Re: Basin Disposal, Inc. and Pasco Sanitary Landfill, Inc.'s Comments on Draft
Consent Decree, Pasco Landfill NPL Site

On behalf of Basin Disposal, Inc., ("Basin") and Pasco Sanitary Landfill Inc., ("PSLI") we provide what follows as Basin and PSLI's comments upon the draft Consent Decree and the accompanying dCAP (draft Cleanup Action Plan) and SOW (Scope of Work) with regard to the Pasco Sanitary Landfill ("PSL").

EXHIBIT 3

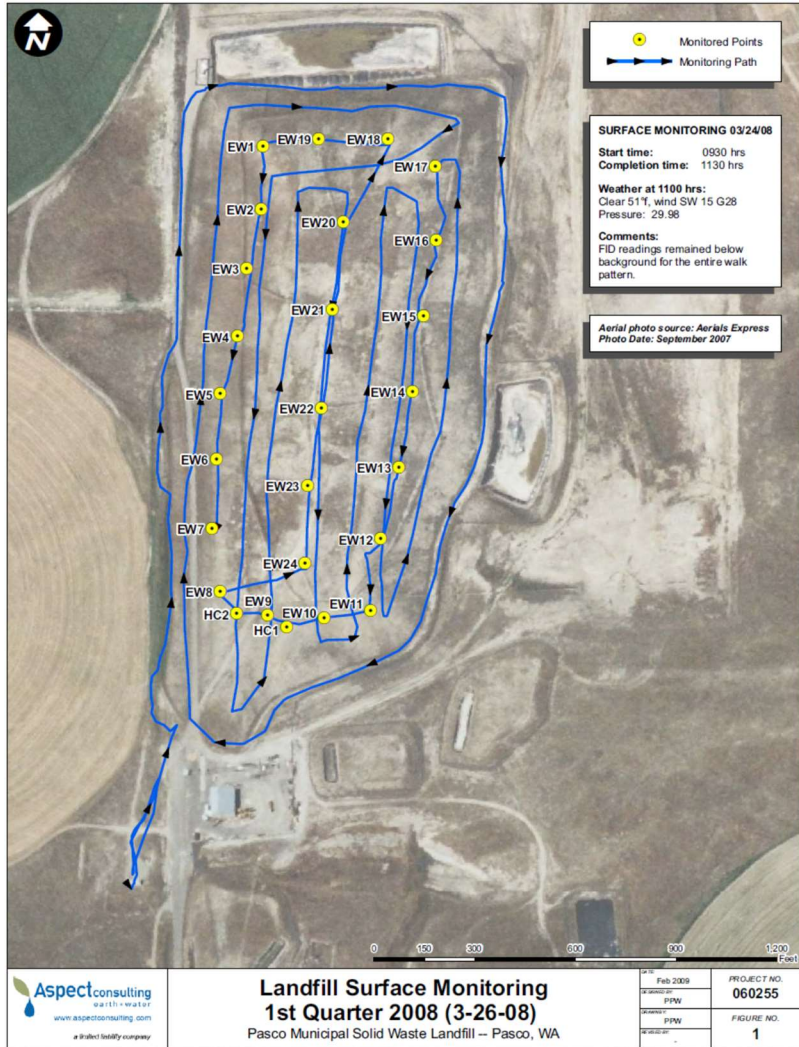
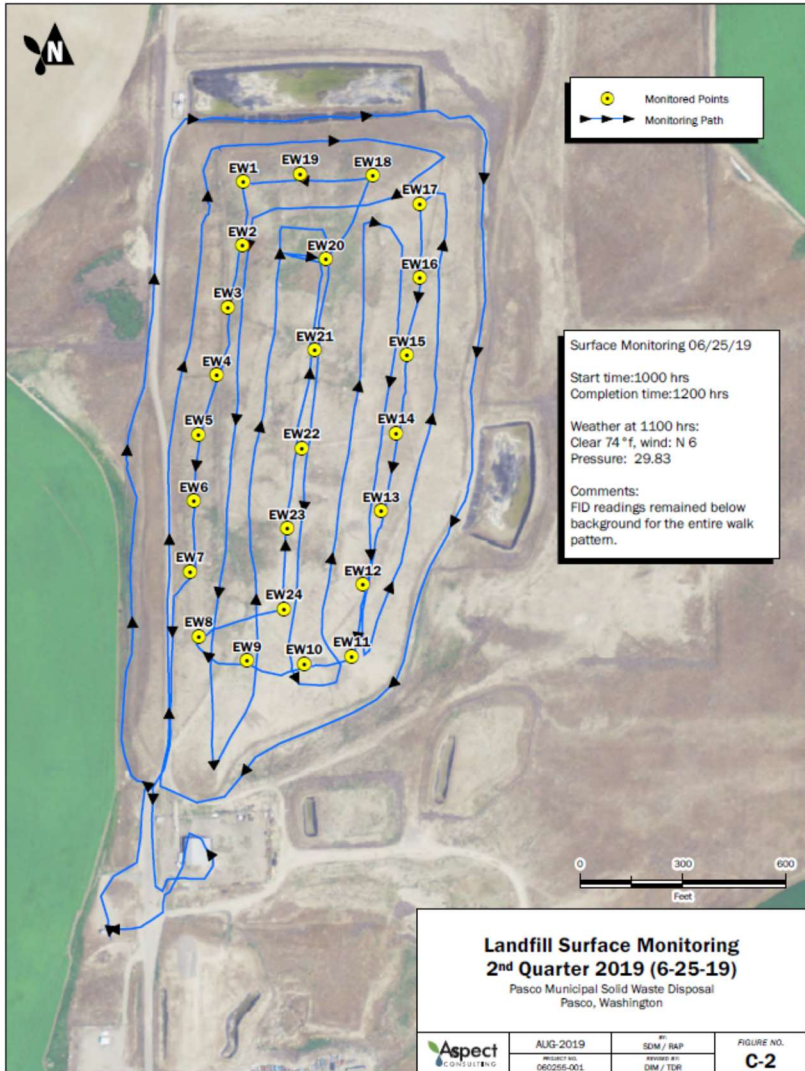
Exhibit 3 is a depiction of the track technicians walked with methane testing gear, every three months, throughout the past 17 years. As the table illustrates, at no time has fugitive methane emissions testing detected *any methane emissions* outside the cap. This demonstrates virtually perfect performance of the cap using that criterion of performance.

EXHIBIT 4

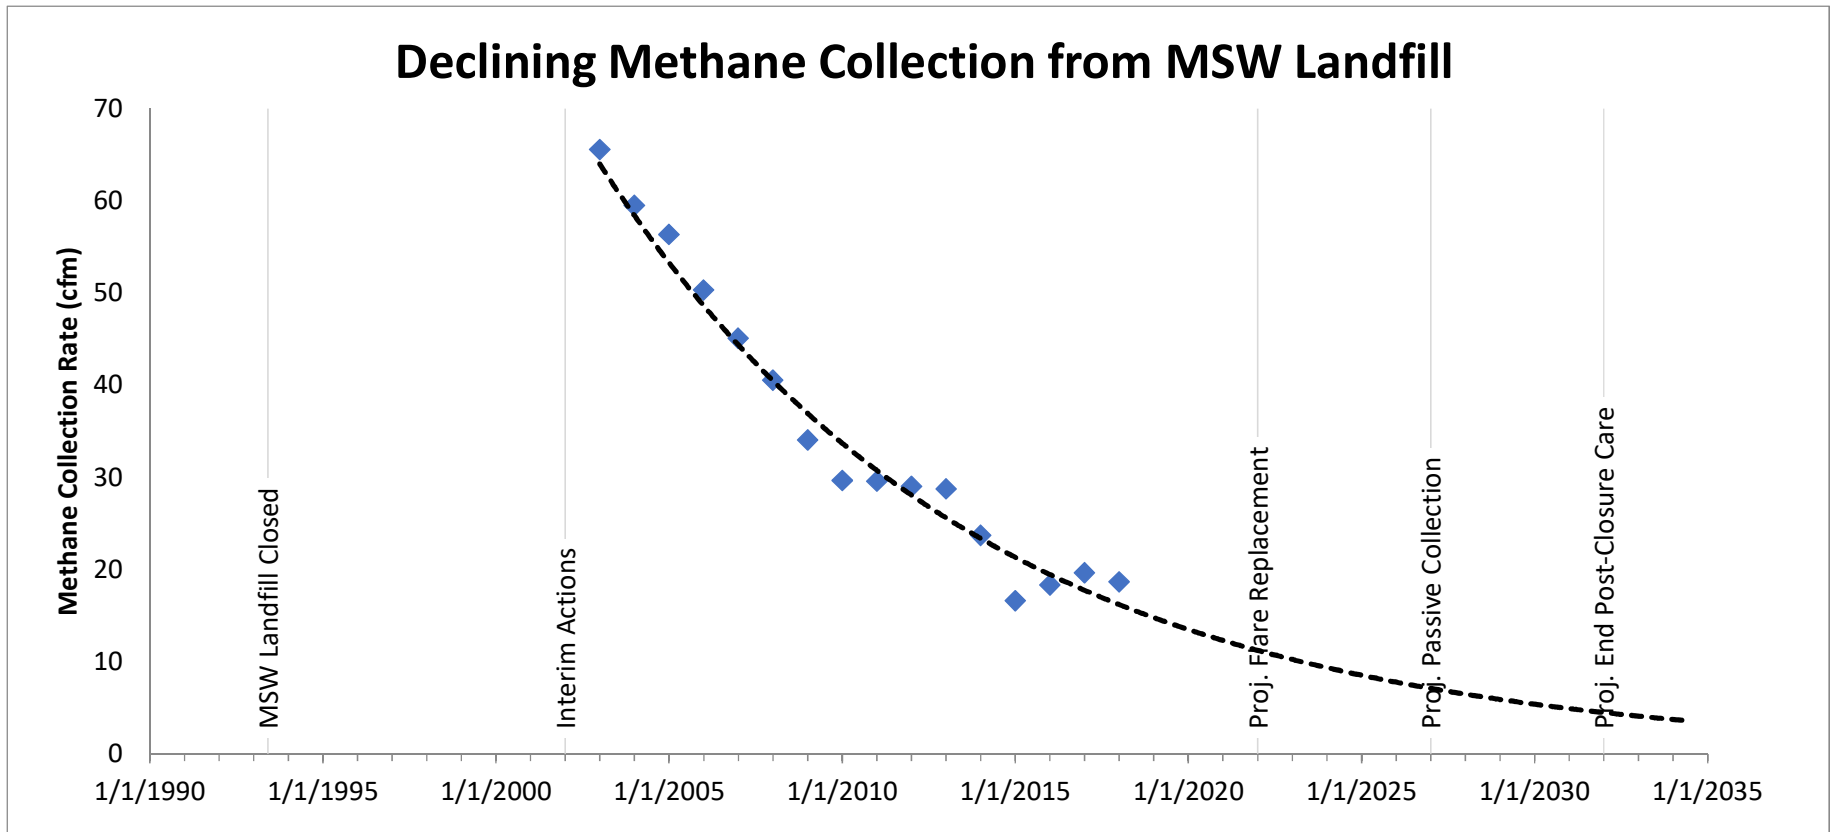
That has been exactly the history of observation of methane production at the PSL since 2002. Exhibit 4 shows the decline of methane production over time from 66 cubic feet per minute in 2003 to 19 cubic feet per minute in 2018. The slope of the graph tracking methane shows methane production has consistently gone down and is now moving toward *de minimis* production levels.

EXHIBIT 5

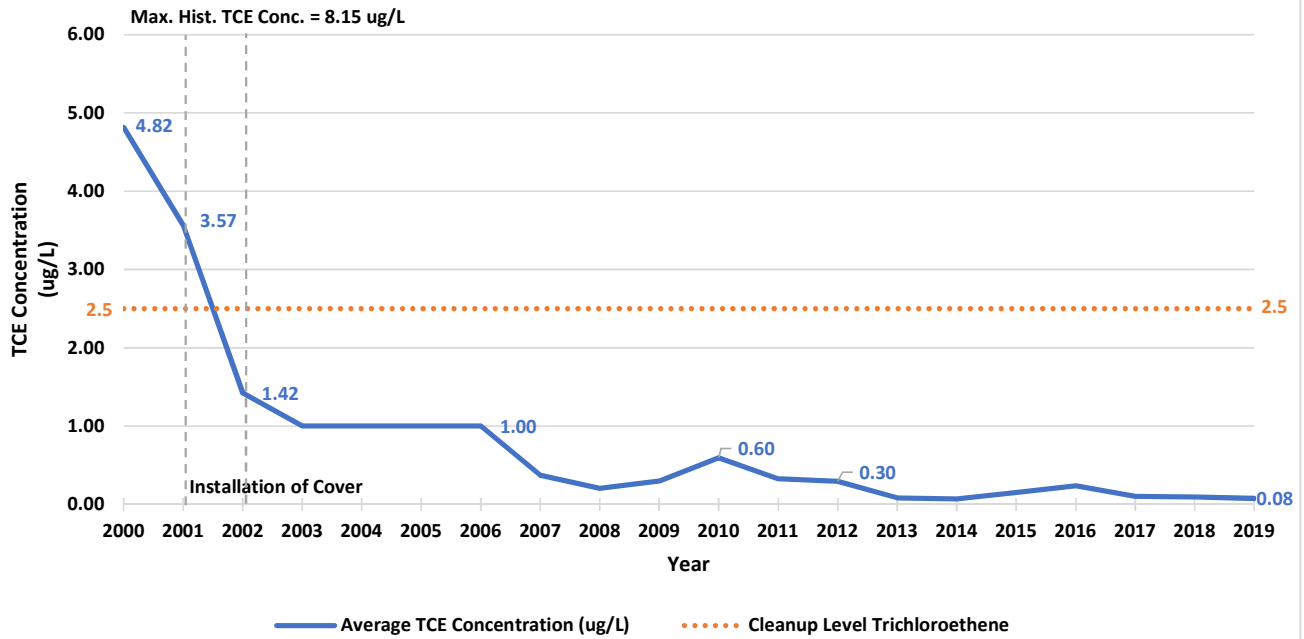
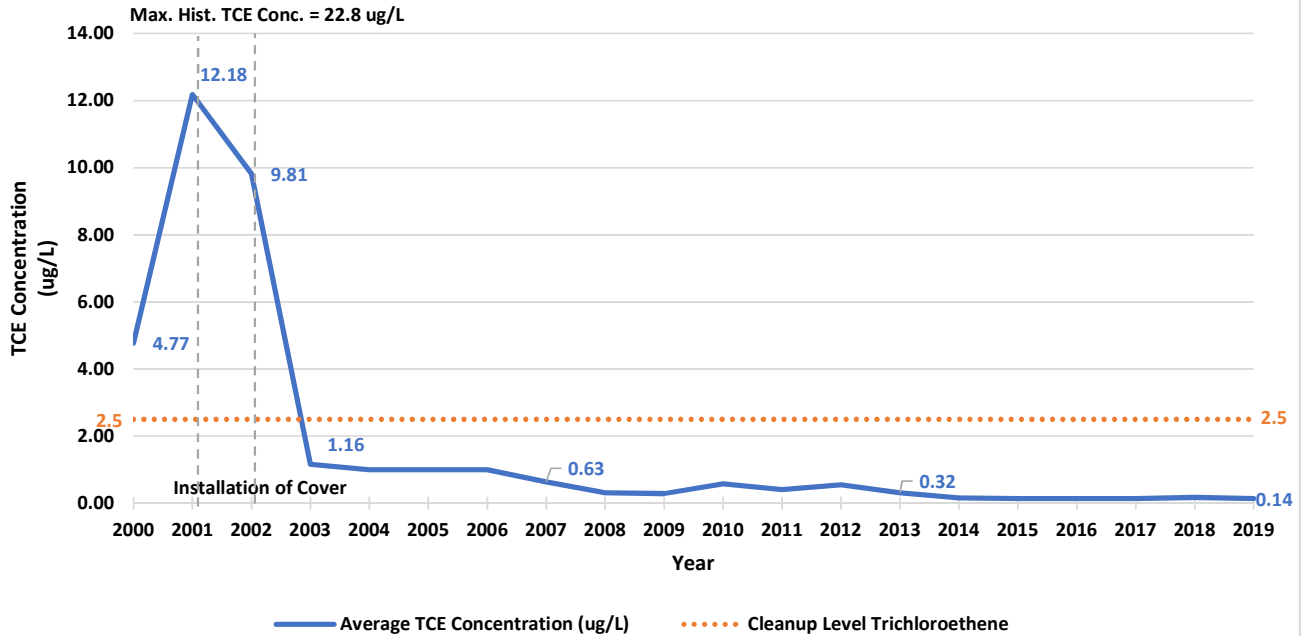
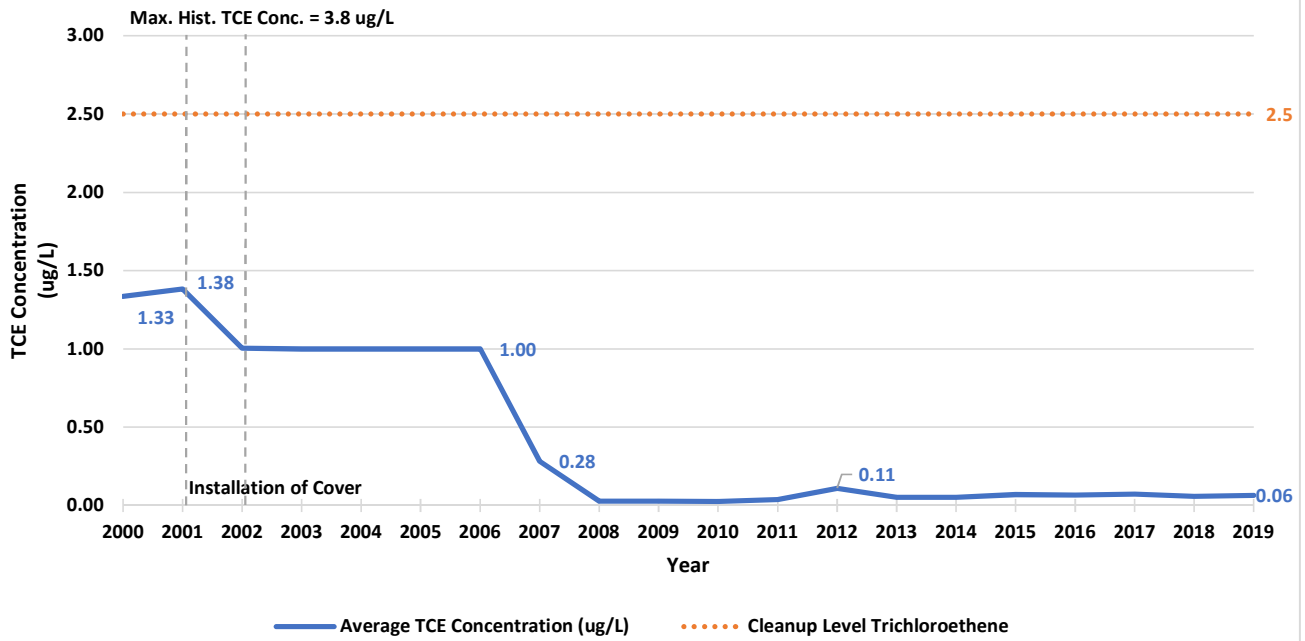
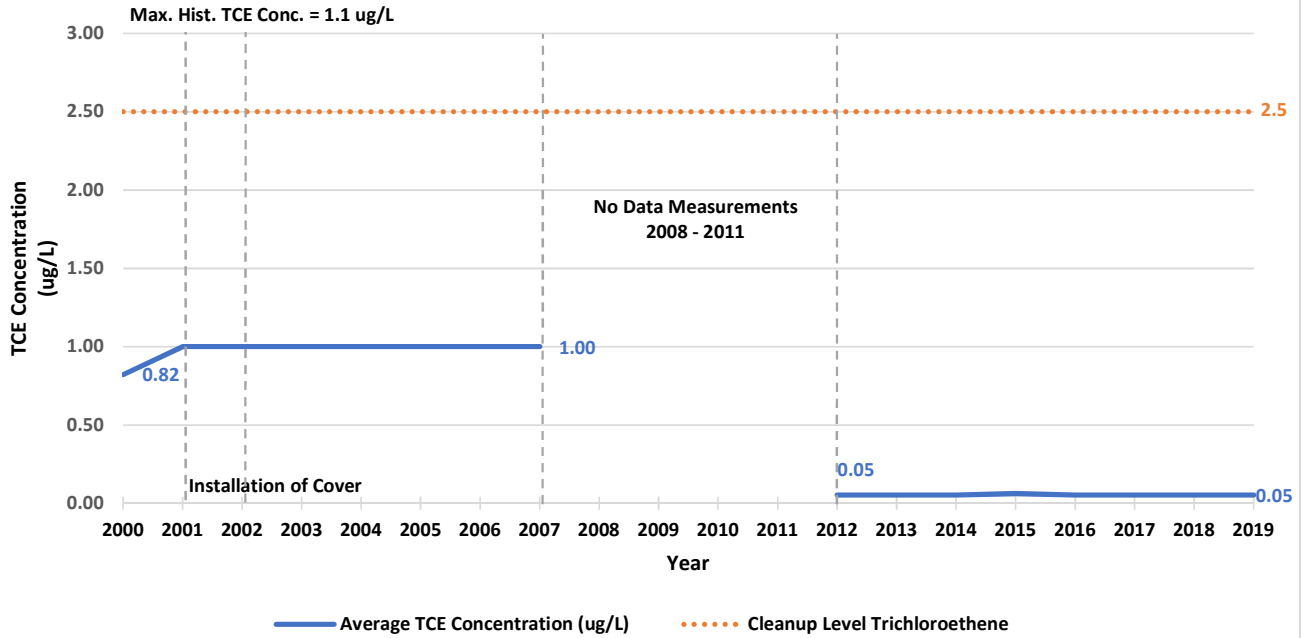
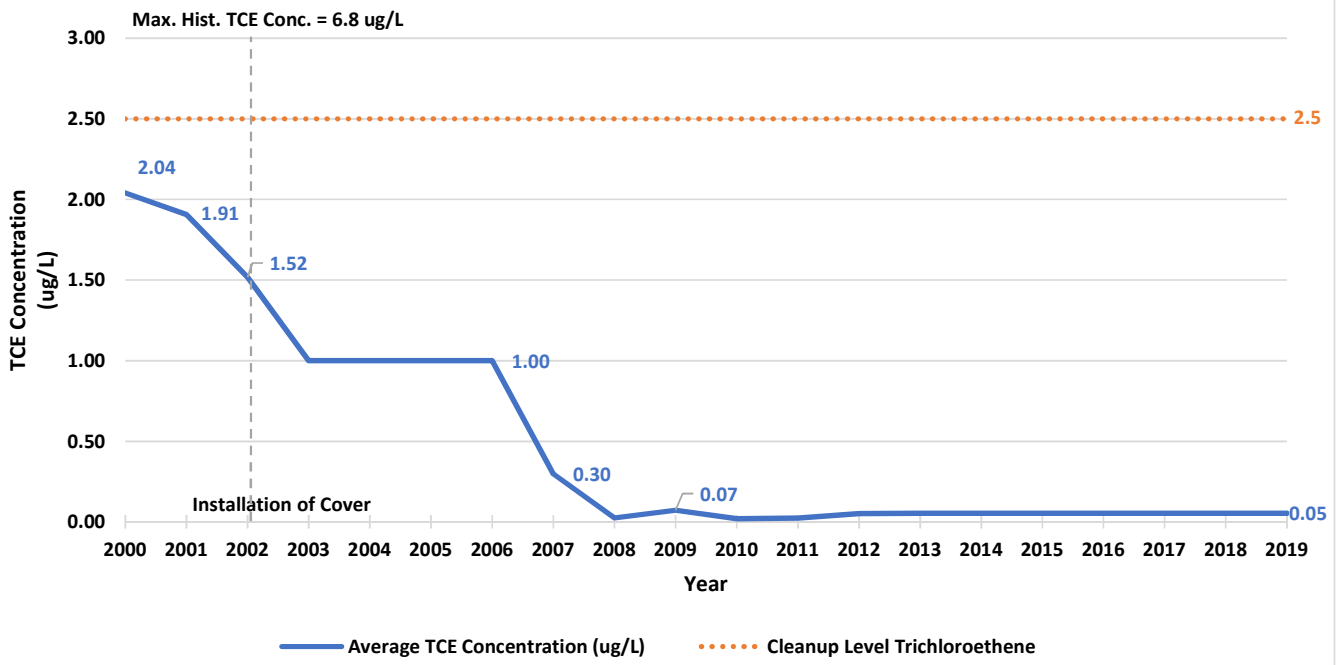
In the 17 years the interim remediation system has been operating, TCE levels have dropped below cleanup levels. This impressive result is borne out in the graphs shown in Exhibit 5, which track the downward trajectory of TCE over a long period, measured at five different wells. We are very pleased with these results which substantiate Basin and PSLI's long held view that the meager amounts of TCE present would be remediated during the interim remedy period.
